SUNDRY NOTICES AND REPORTS ON WELLS
Do not use this form for proposals to drill or to re-enter an abandoned well. Use form 3160-3 (APD) for such proposals.

1. Type of Well <input checked="" type="checkbox"/> Oil Well <input type="checkbox"/> Gas Well <input type="checkbox"/> Other		8. Well Name and No. POLO AOP FEDERAL COM 6
2. Name of Operator YATES PETROLEUM CORPORATION Contact: TINA HUERTA E-Mail: tinah@yatespetroleum.com		9. API Well No. 30-015-28871
3a. Address 105 SOUTH FOURTH STREET ARTESIA, NM 88210	3b. Phone No. (include area code) Ph: 575-748-4168 Fx: 575-748-4585	10. Field and Pool, or Exploratory PENASCO; WOLFCAMP
4. Location of Well (Footage, Sec., T., R., M., or Survey Description) Sec 10 T19S R25E SWSE 660FSL 1980FEL		11. County or Parish, and State EDDY COUNTY, NM

**Polo AOP Fed Com 6
30-015-28871
Yates Petroleum Corporation
July 19, 2013
Conditions of Approval**

Before

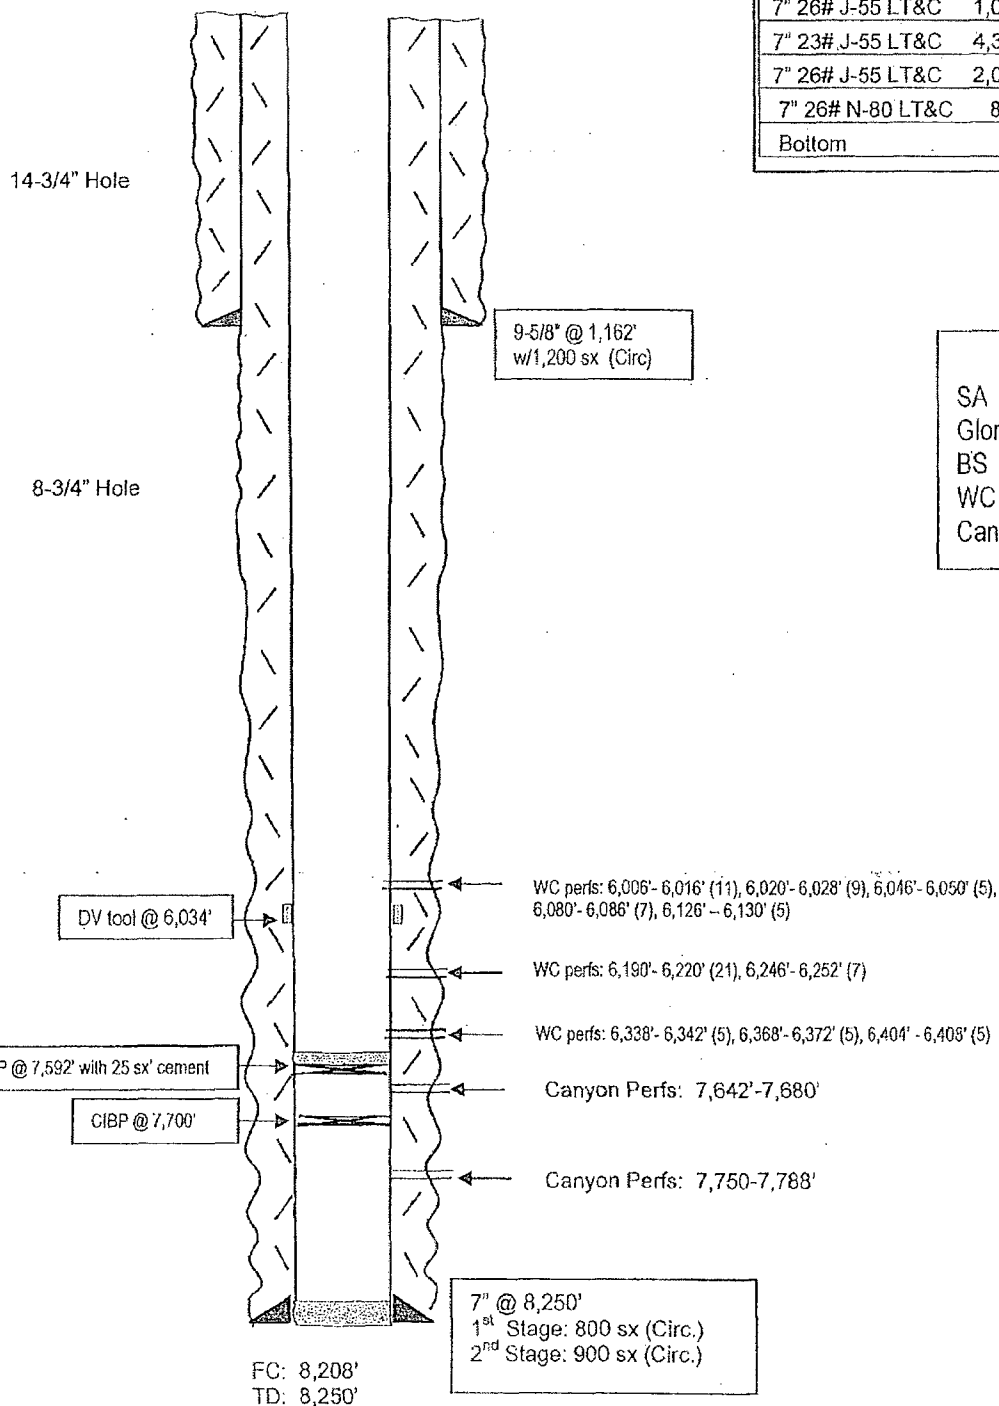
always include current & proposed well bore diagrams + C/OZ

- 1. Operator shall set a CIBP at 5,956' and place 25 sx Class C cement. Tag required.**
- 2. Operator shall set a balanced neat class C cement plug from 5,653'-5,497' to seal the Wolfcamp formation.**

- 3. Operator shall set a balanced neat class C cement plug from 3,718'-3,581' to seal the Bone Spring formation.**
- 4. Must conduct a casing integrity test before perforating and fracturing. Submit results to BLM. The CIT is to be performed on the production casing to max treating pressure. Notify BLM if test fails.**
